PROJECT No.	COL.MOD.UK.0003509
CELL No.	95555

SITE No UK-MY-005554
J & L SUPPLIES
J & L SUPPLIES
11A CADDICK ROAD
SOUTH KNOWSLEY
MERSEYSIDE
L34 9HP

TITLE
PROPOSED ELEVATION
CONSTRUCTION
BTEE LTD

DRG No. UKMY005554-02-301-G0001 | Sheet 1 of 1 | Rev 1.A

PROPOSED NORTH-WEST ELEVATION

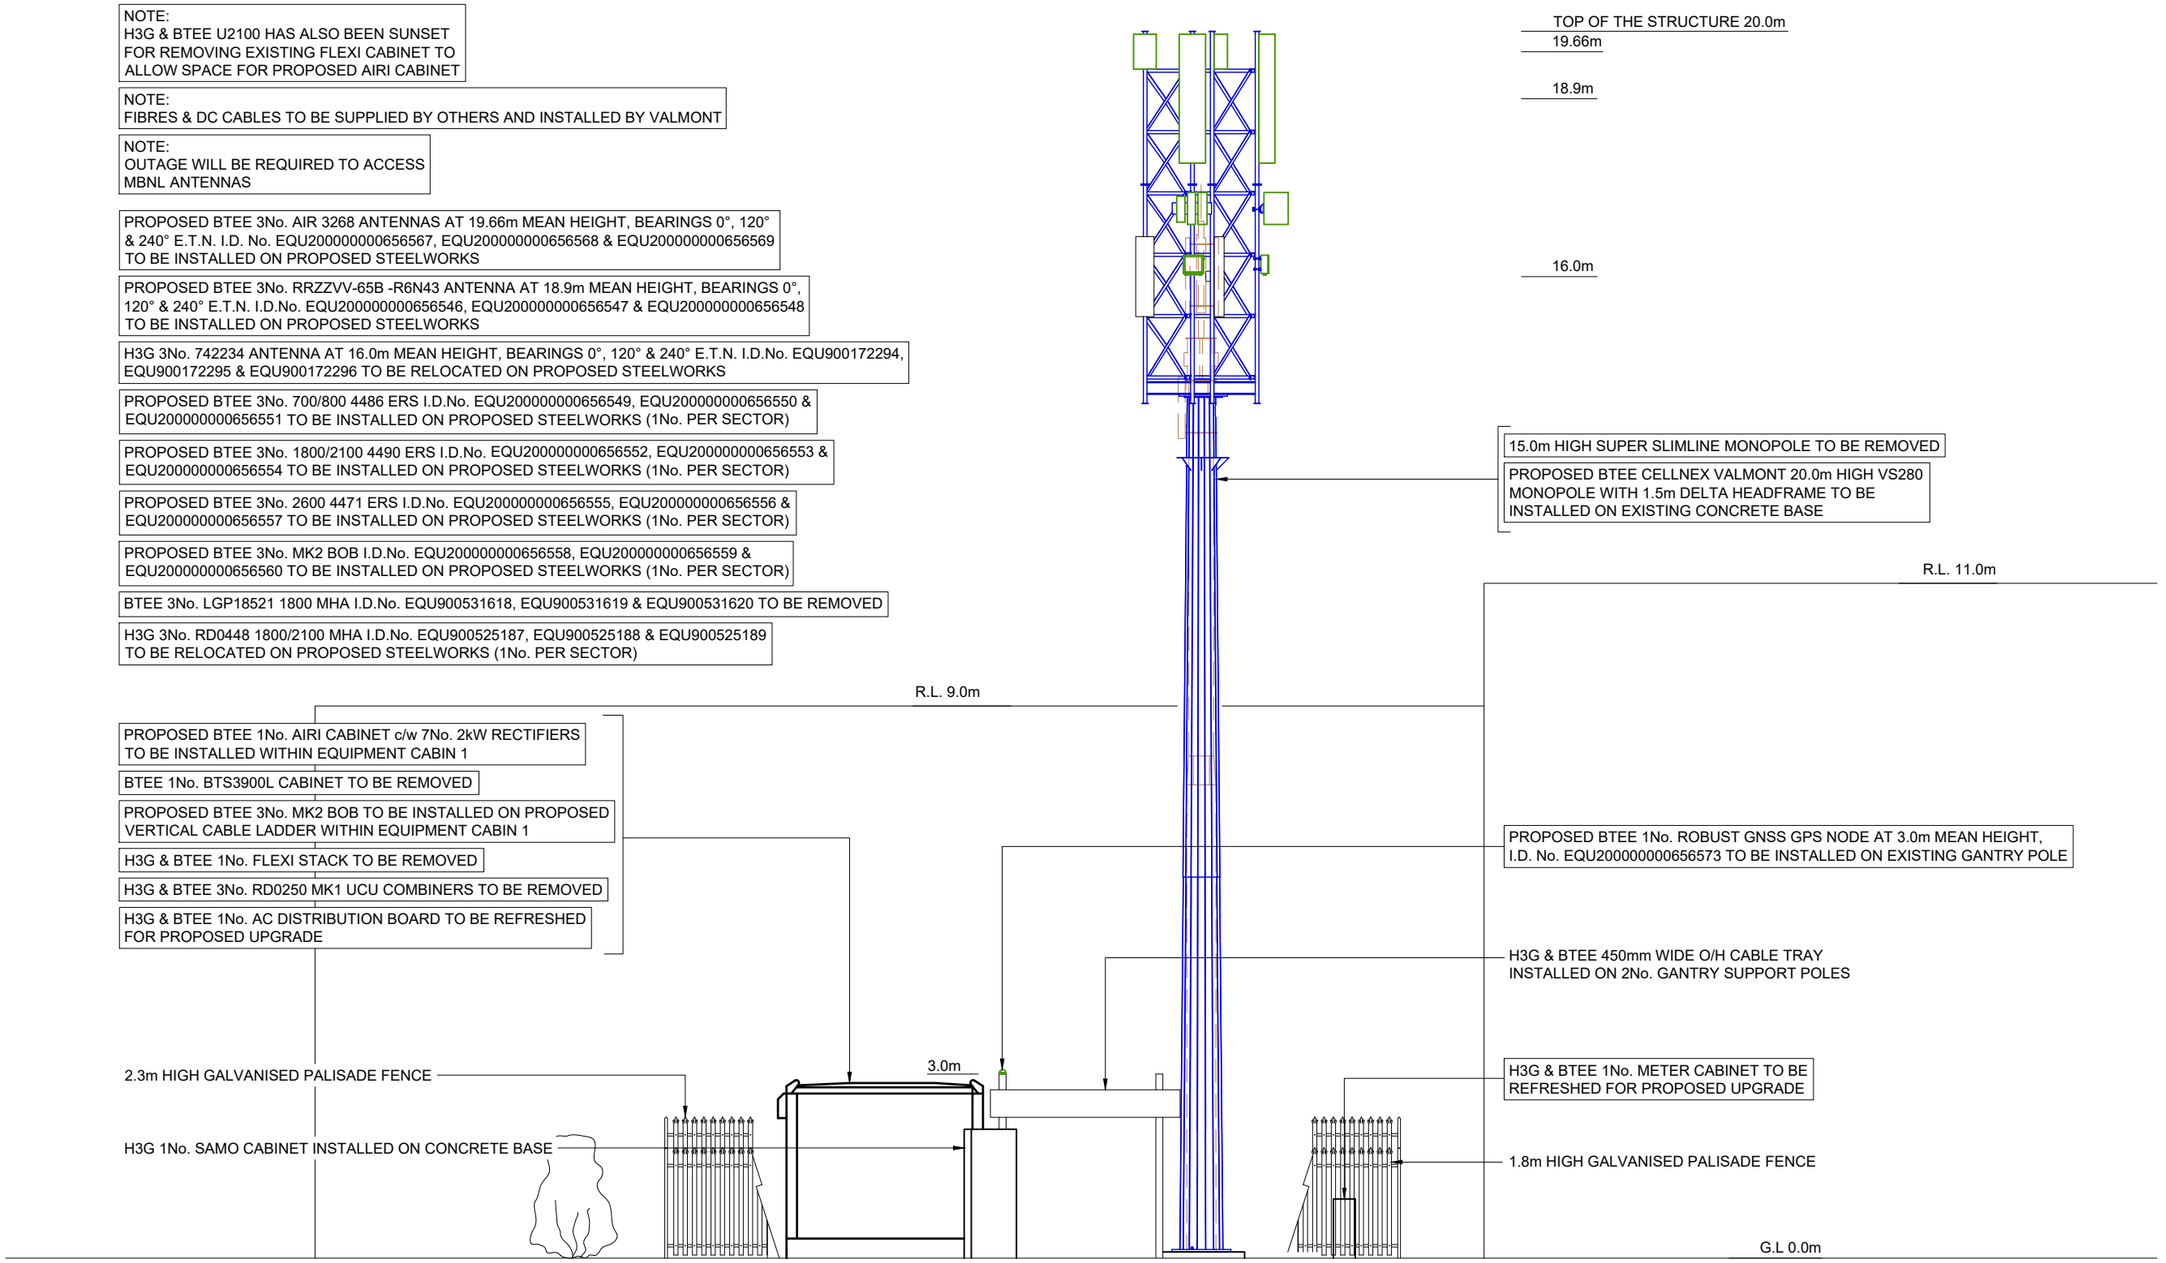
CHANGE DESCRIPTION:
- THE EXISTING MONOPOLE IS TO BE REPLACED WITH THE PROPOSED VS280 MONOPOLE
- PROPOSED ANTENNAS MEAN HEIGHT HAS BEEN UPDATED
